Aluminum Storefront - Kawneer IR501 Product Details

Date: 5.12.04 Project: Stennis ROP

Aluminum Storefront - Kawneer 1600 Wall Product Details (Window C - Bldg 2440)

Kawneer 1600 Wall UFC Performance Test Report

KAWNEER IR 501 SYSTEM

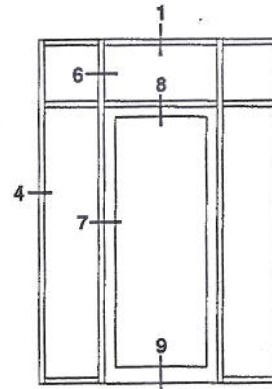
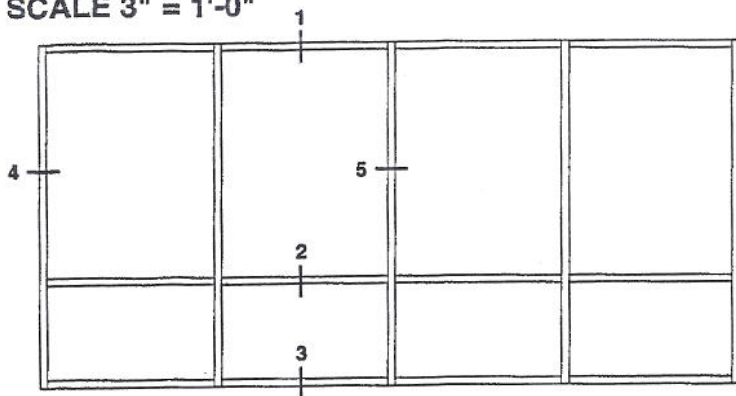
To be used at all typical window openings
with exception of Window "C" at Bldg 2440
which will require "1600 Wall" Framing

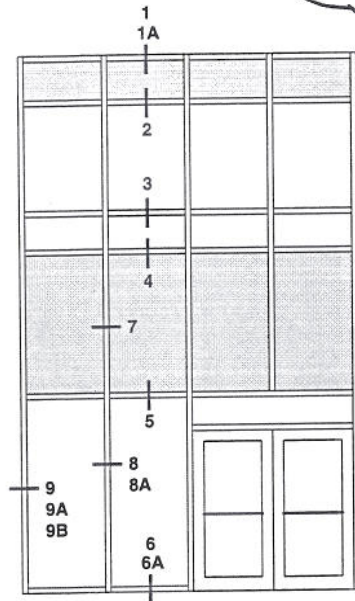
RIVERINE PROJECT WILL UTILIZE
 1 5/16" INSULATED-LAMINATED GLASS
 INFILL IN LIEU OF 1" SHOWN

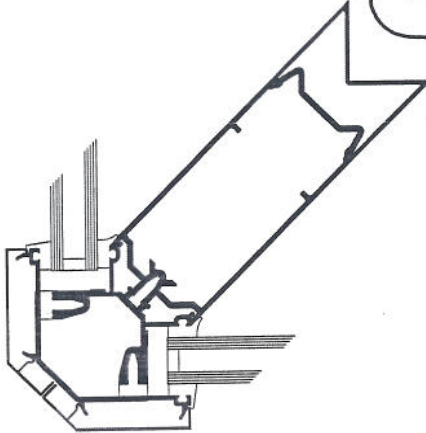
RIVERINE PROJECT LEAN-OUT WINDOW TYPE "C"
ON BLDG 2440 WILL USE SIMILAR CORNER
DETAIL

1-5/16" INFILL (LMI) *LARGE MISSILE IMPACT

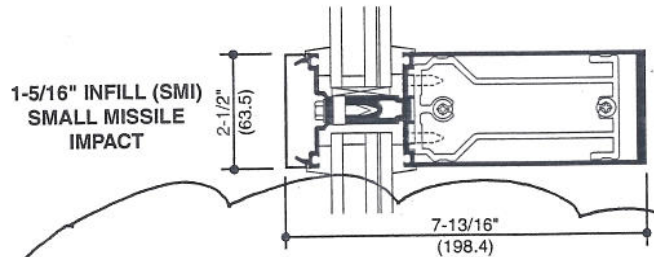
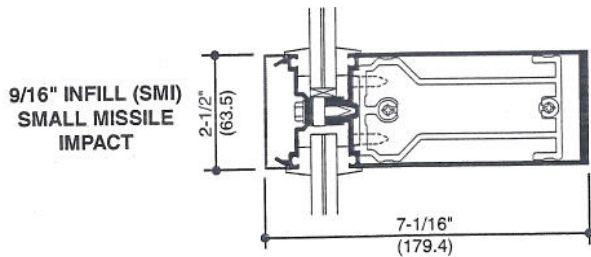
APPLICABLE TO RIVERINE PROJECT
